Our Ref: TR/I0869/mr

2 November, 2020

**RE: PARRAMATTA WESTFIELD SHOPPING CENTRE
S75W APPLICATION – RESPONSE TO TRAFFIC MATTERS**

6.4m SMALL RIGID VEHICLE
SWEPT PATHS

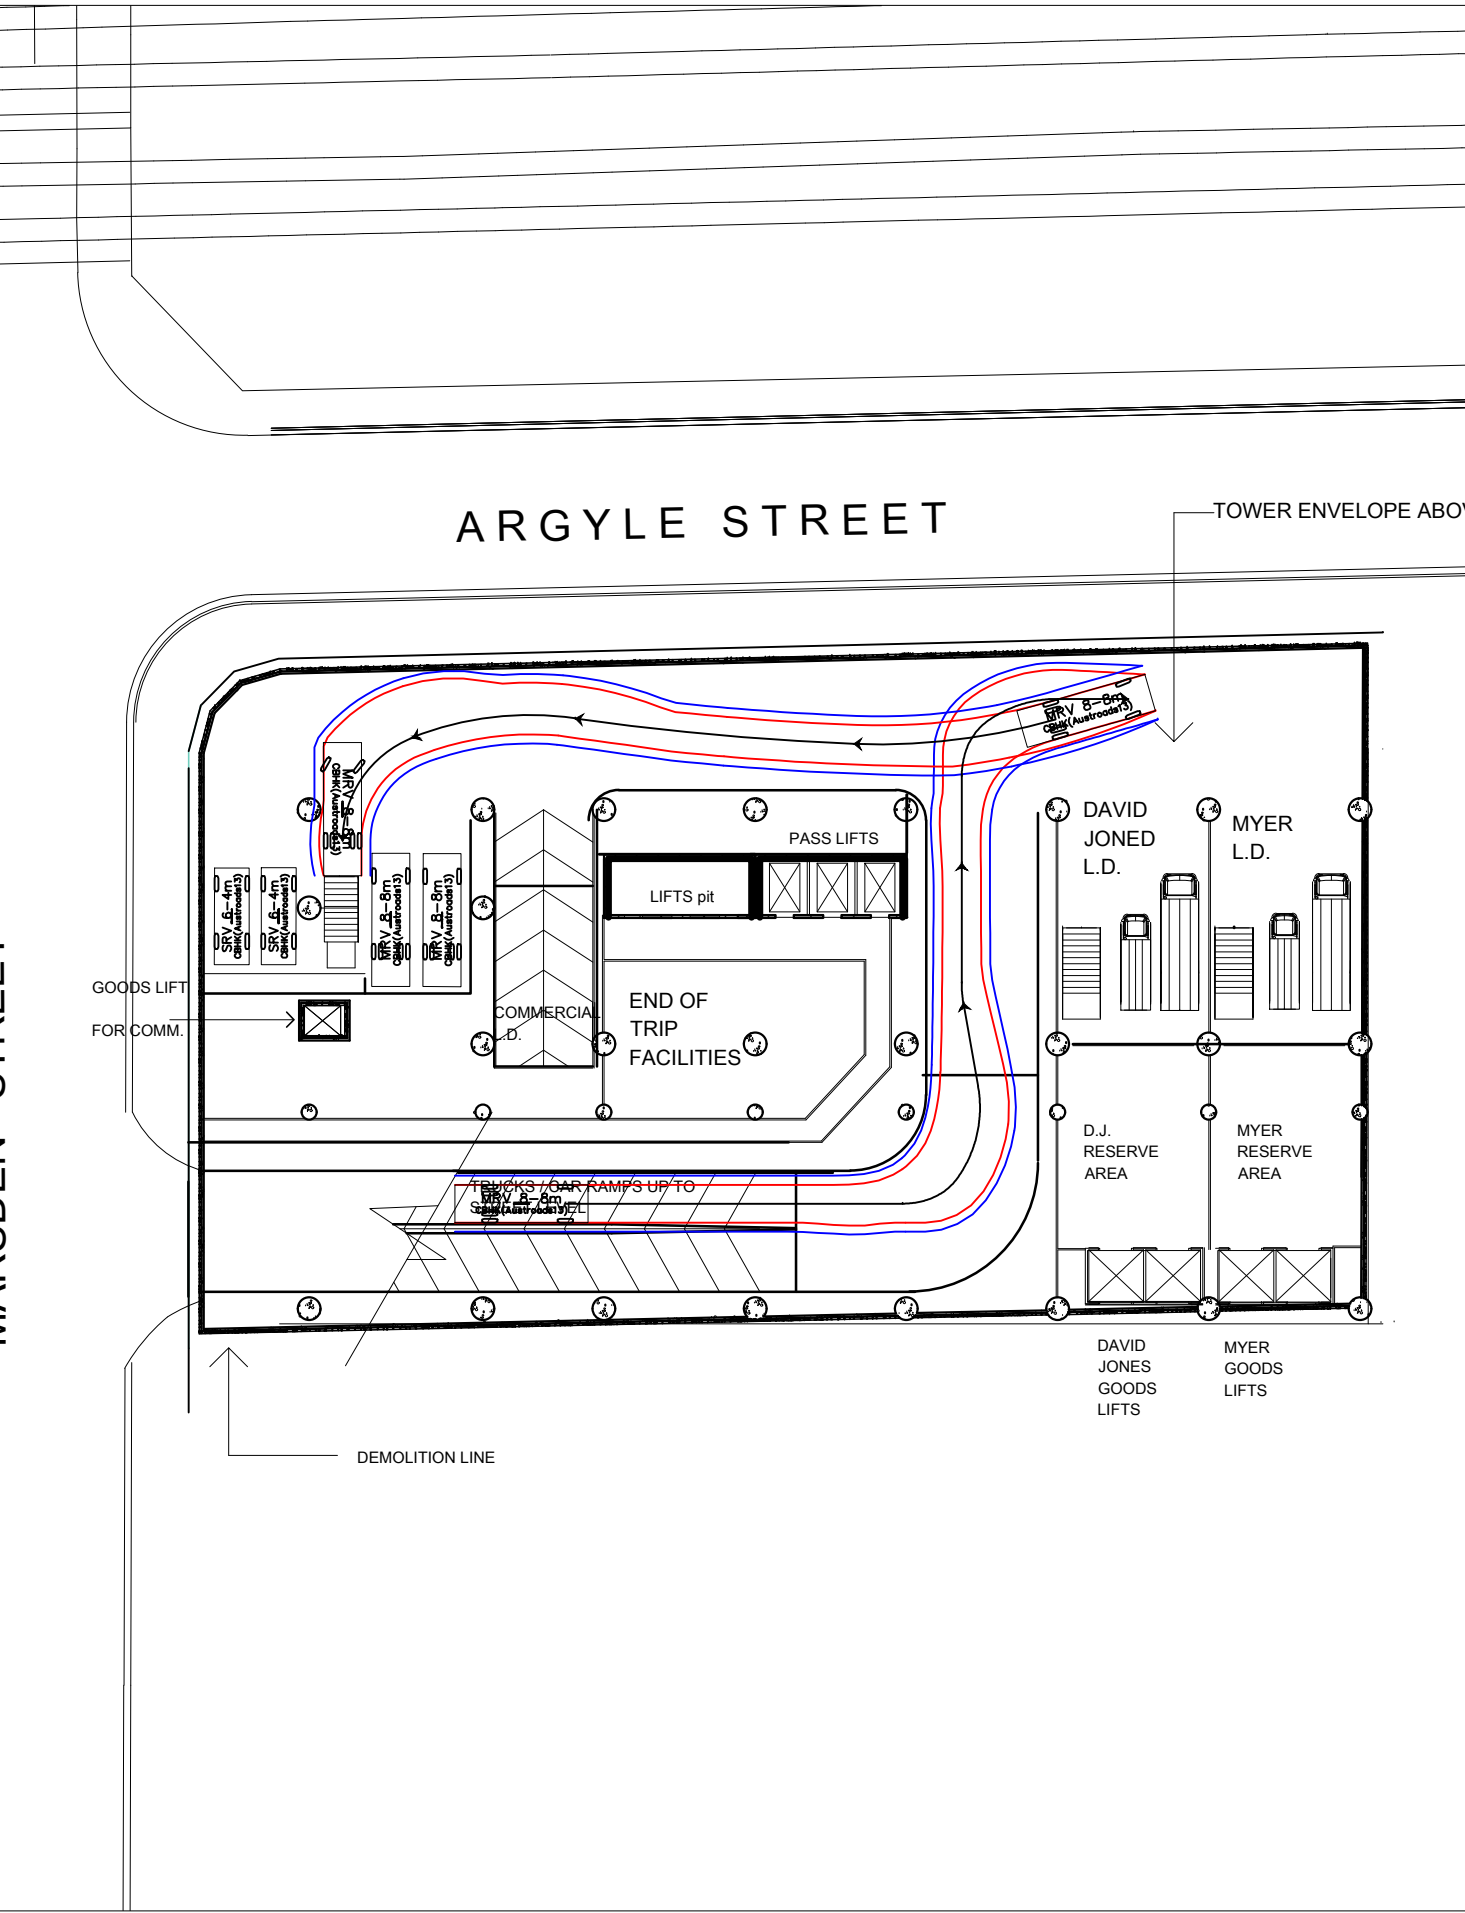
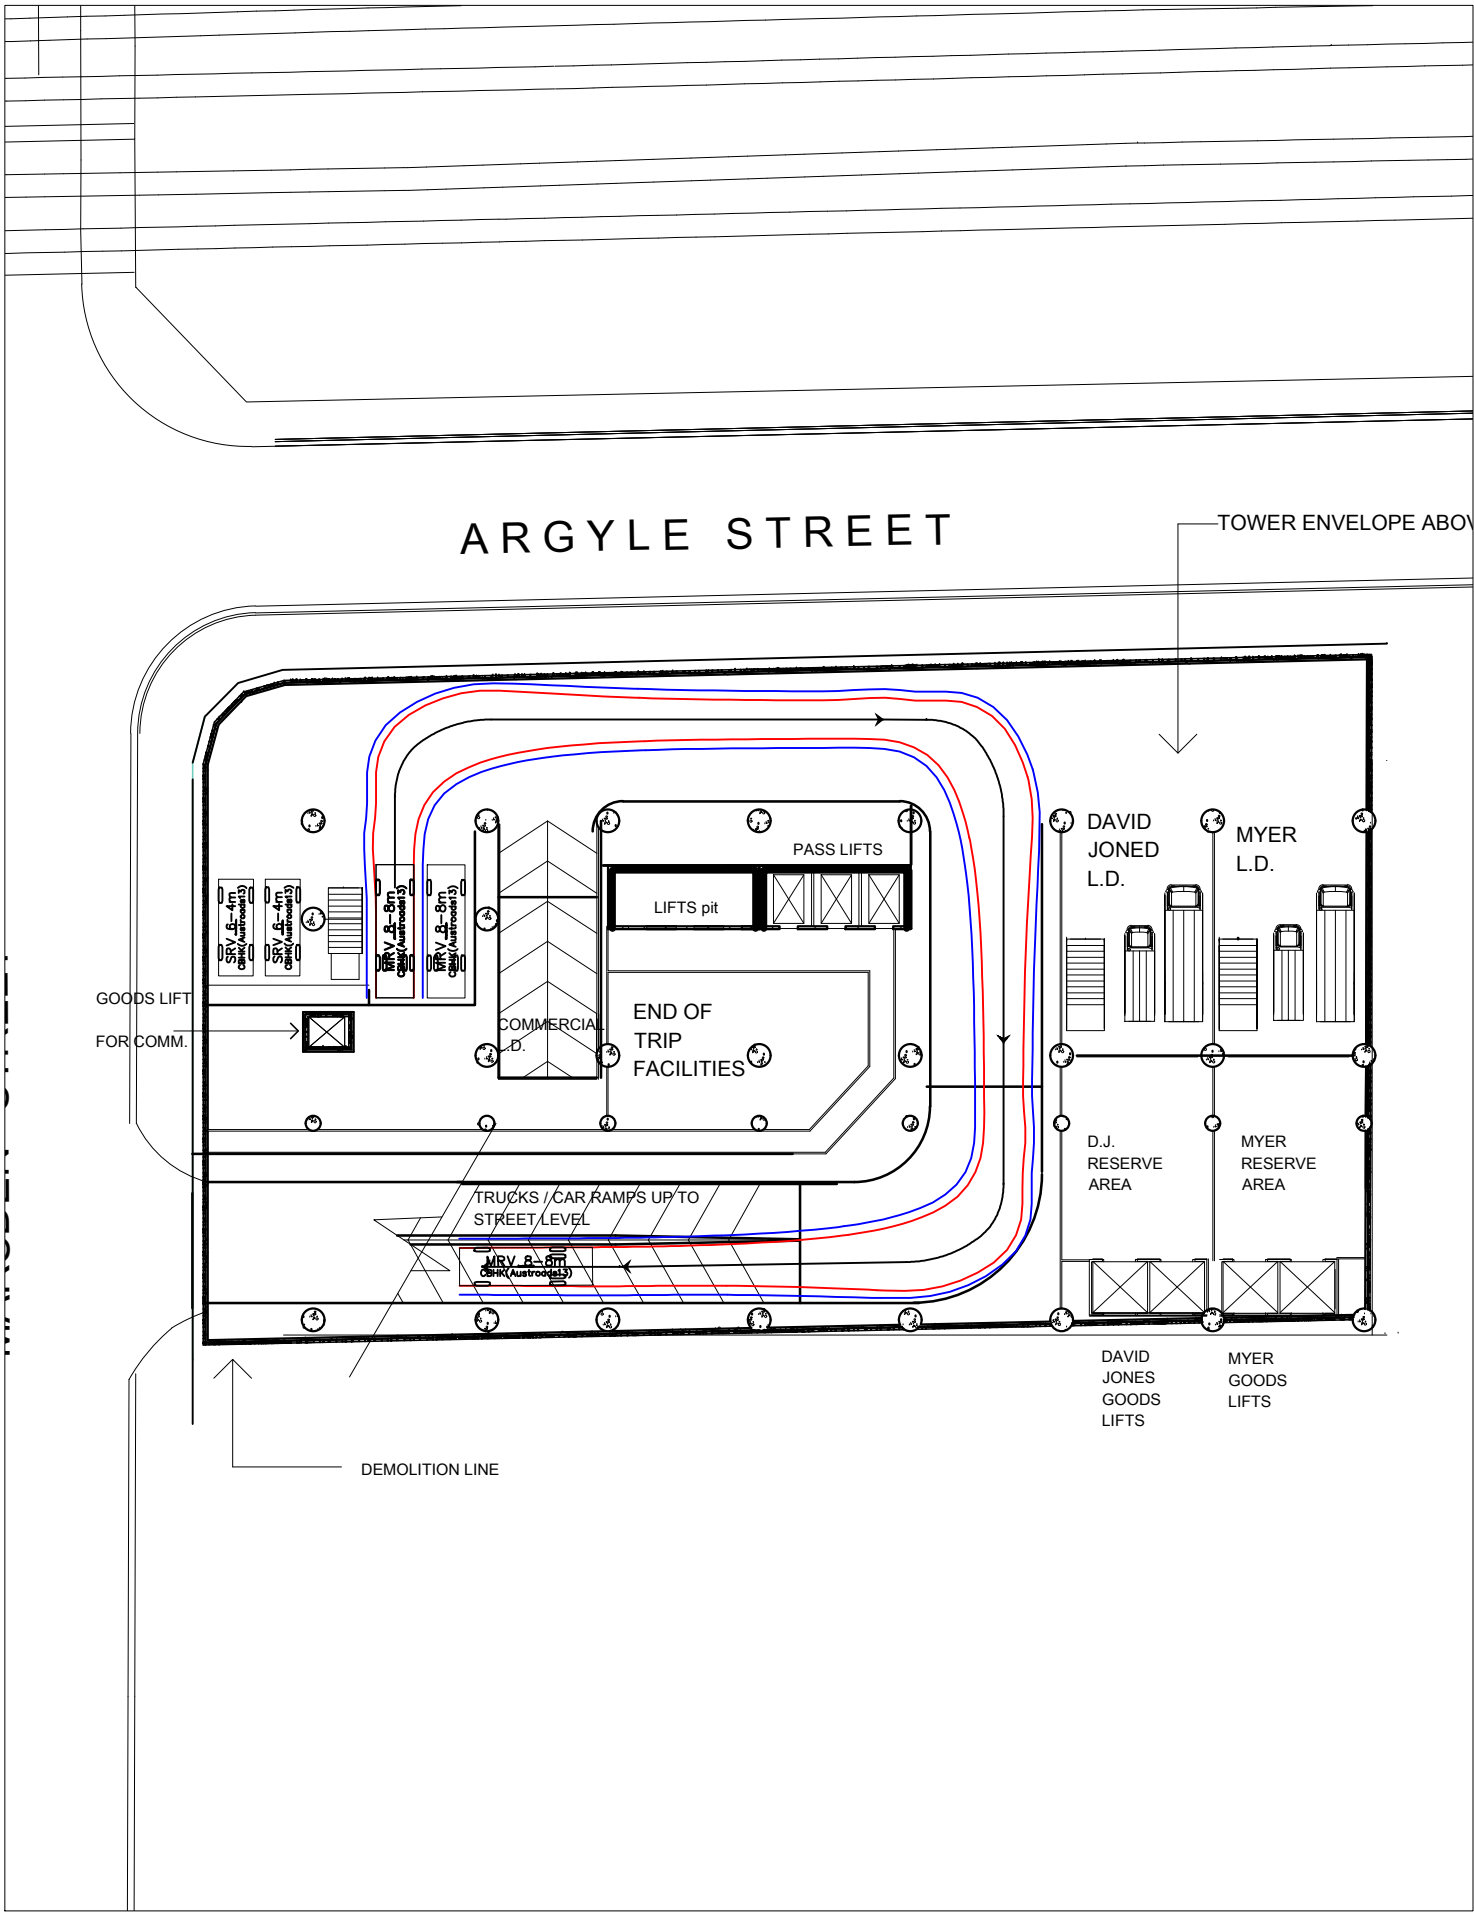
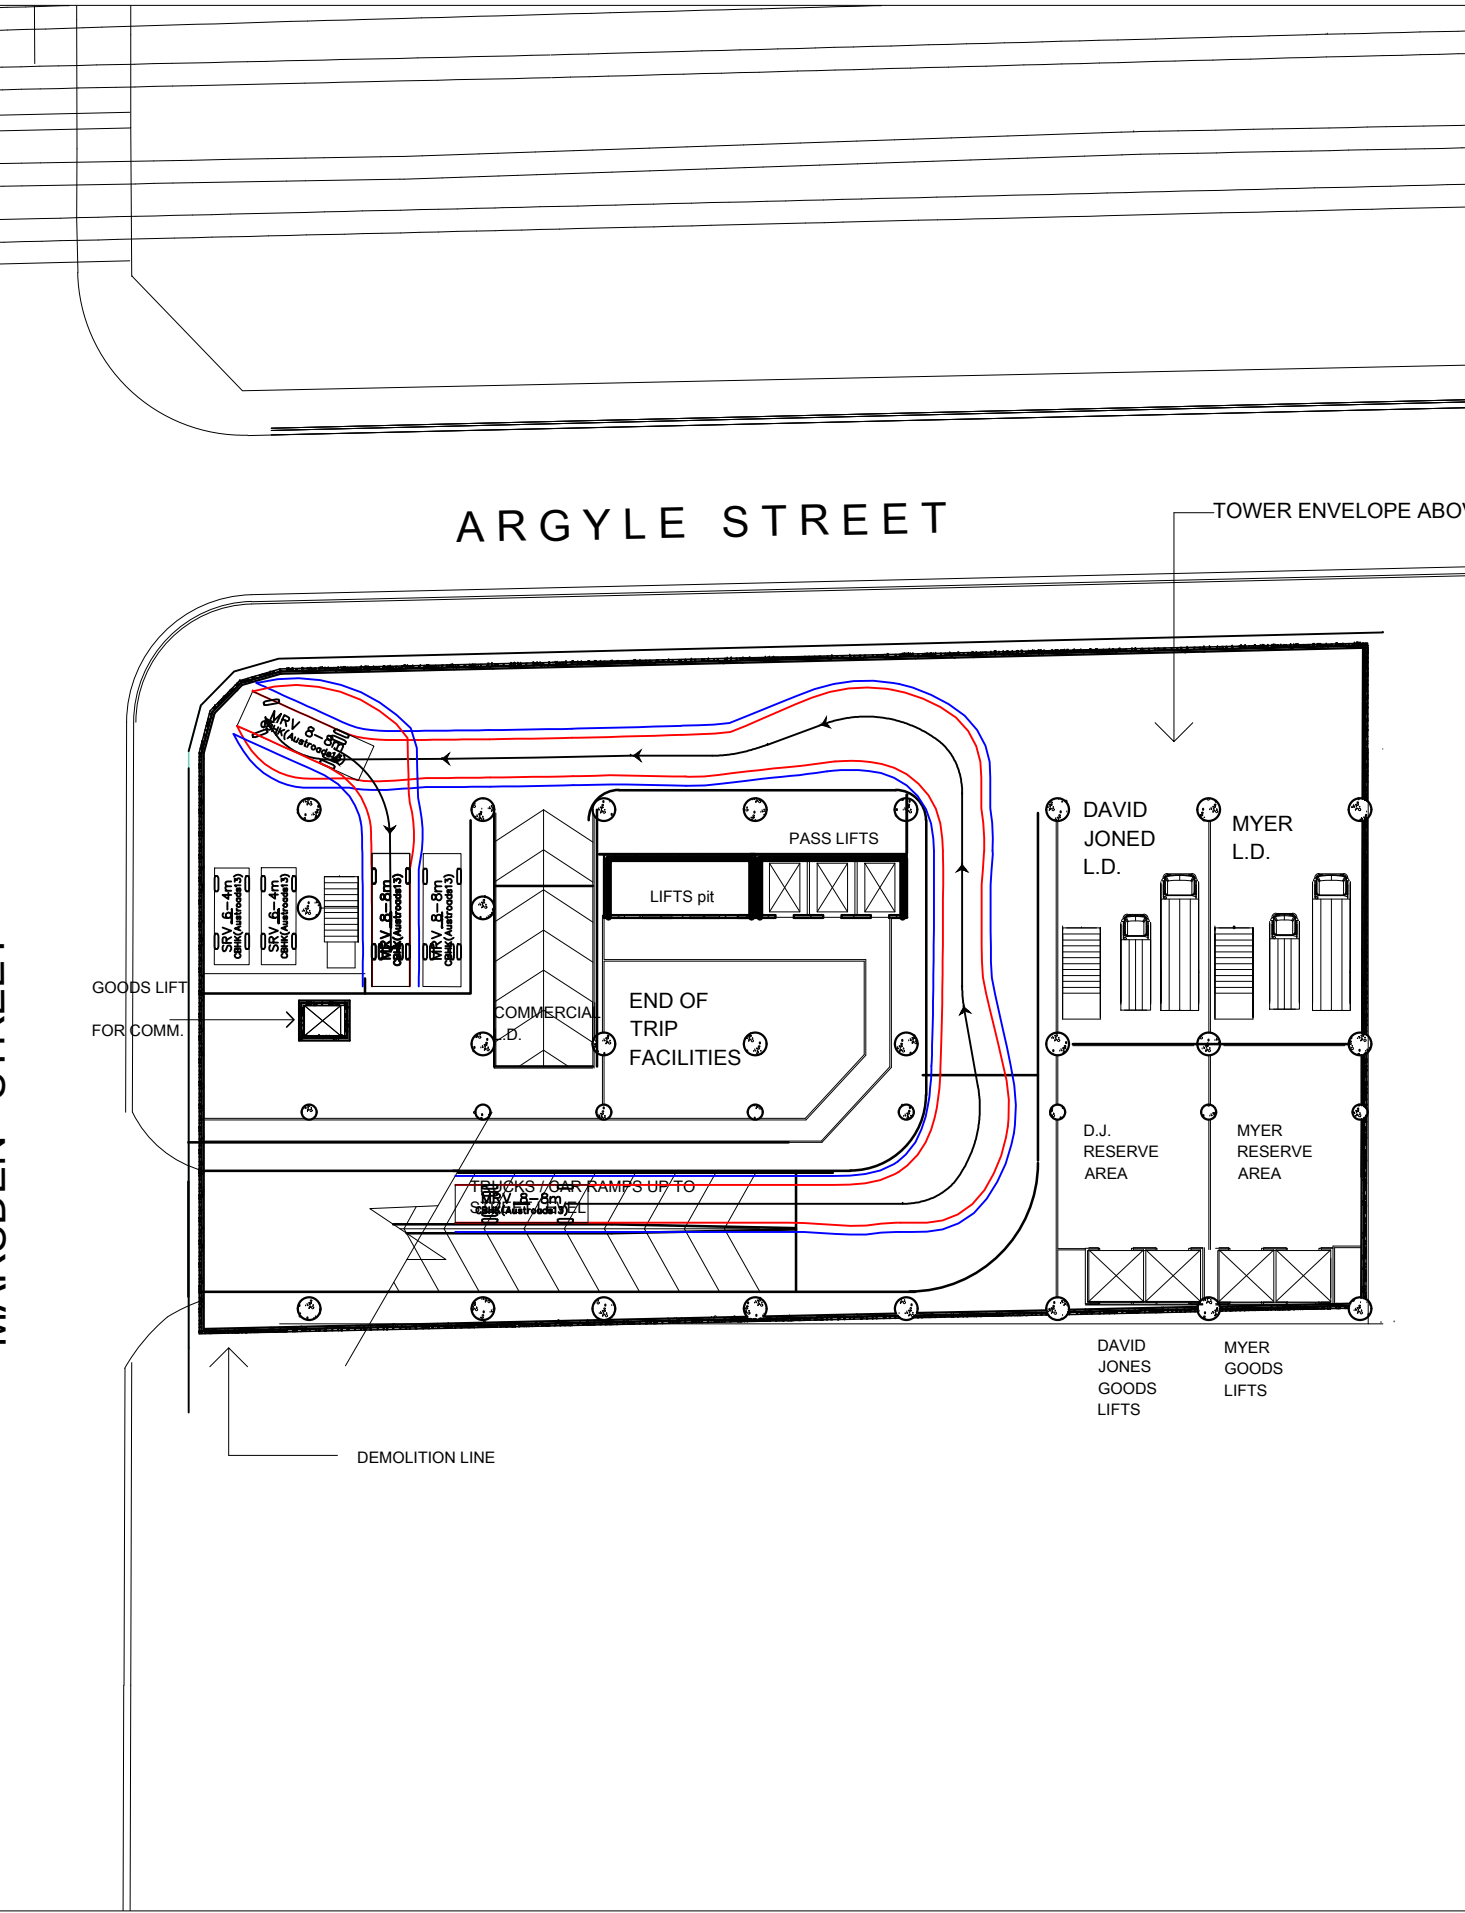
17. TfNSW has requested additional information with regards to the number of service vehicle movements associated with the S75W application, their impact on the surrounding road network and the capacity of the exiting dock to accommodate the additional deliveries for the office tower.

19. Indicative plans of the proposed loading dock are shown in Attachment A with truck turning paths. These show:
- access from Marsden Street (limited to left in/left out by the existing median;

- four loading bays for the office tower;
 - two loading bays each for David Jones and Myer;
 - largest truck that would access the dock being a 8.8 metre rigid truck; and

- all vehicles entering and departing the dock in a forward direction.
20. With regards to the capacity of the existing dock to accommodate the additional demand, as part of a future DA for the relocated office tower, a loading dock management plan would be prepared addressing the matters raised by TfNSW. This would allow further work to be undertaken as part of the DA to address the minor design changes required to the design of the loading dock (as shown on the attached truck swept paths).
